APPLICATION NO.	FILING DATE	FIRST NAMED INVENTOR	ATTORNEY DOCKET NO.	CONFIRMATION NO.
10/785,977	02/26/2004	Ichiro Amamori	D-1573	2686

Office Action Summary	Application No.	Applicant(s)	
	10/785,977	AMAMORI, ICHIRO	
	Examiner	Art Unit	
	Joselynn Y. Sliteris	3616

DETAILED ACTION

FIG. 16A

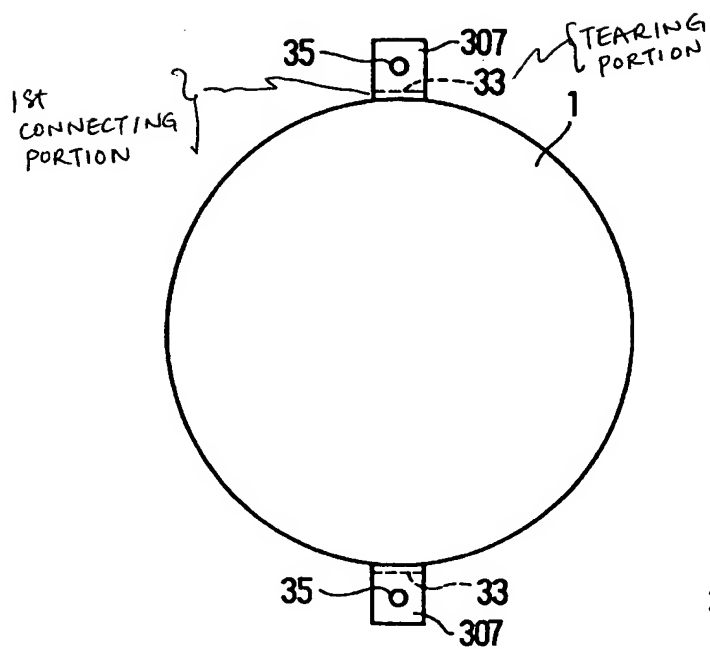
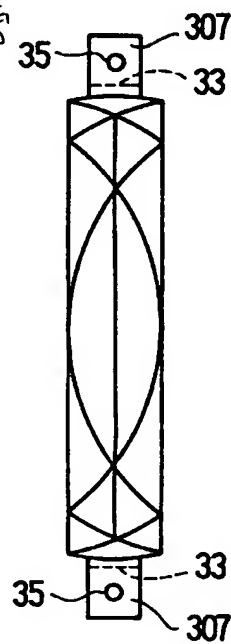
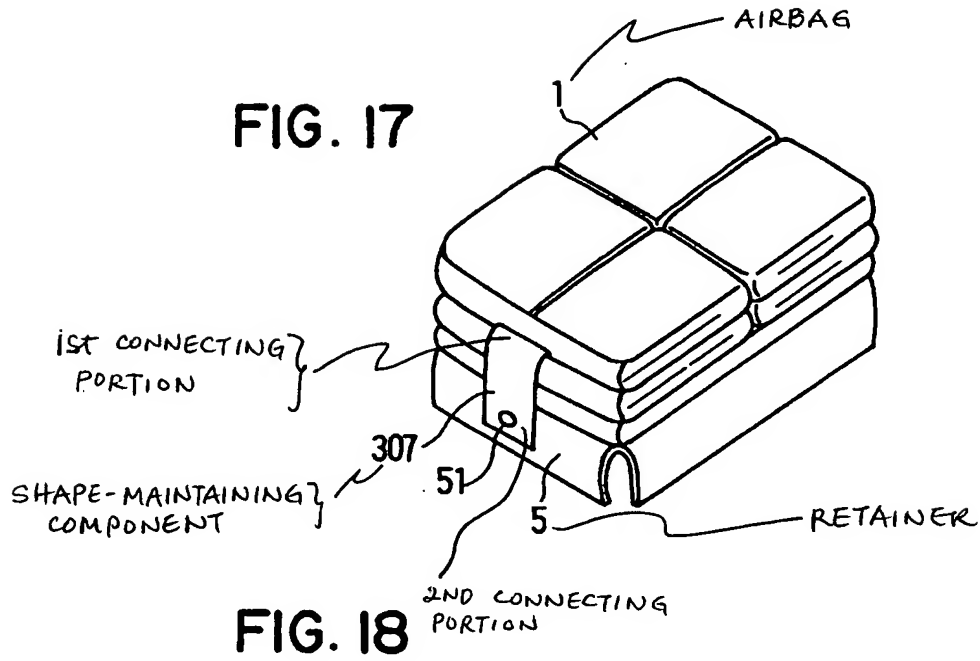
a shape-maintaining component 307 having a first connecting portion connected to the front portion of the airbag and a second connecting portion attached to a lower part of the retainer 5 for covering the airbag in a folded state so that the one end of the inflator 8 is placed in the insertion port behind the first connecting portion (Figs. 16A-17 --- see attached annotations),

wherein said first connecting portion of the shape-maintaining component is located above the insertion port,

wherein said shape-maintaining component 307 includes a tearing portion 33 around the first connecting portion, said tearing portion being torn when the airbag is inflated.

Regarding claims 5, Kato discloses the shape-maintaining component including a main part having the first connecting portion, and the second connecting portion formed

of a flap extending outwardly from the main part and connected to the lower part of the retainer 5 (Figs. 16A-17). But Kato does not disclose the second connecting portion being formed of a plurality of flaps. However, a plurality of flaps represents a change in number, not in kind and as such, would have been obvious to one of ordinary skill in the art at the time the invention was made form the second connecting portion of Kato with the plurality of flaps so as to improve attachment of the shape-maintaining component to the retainer.
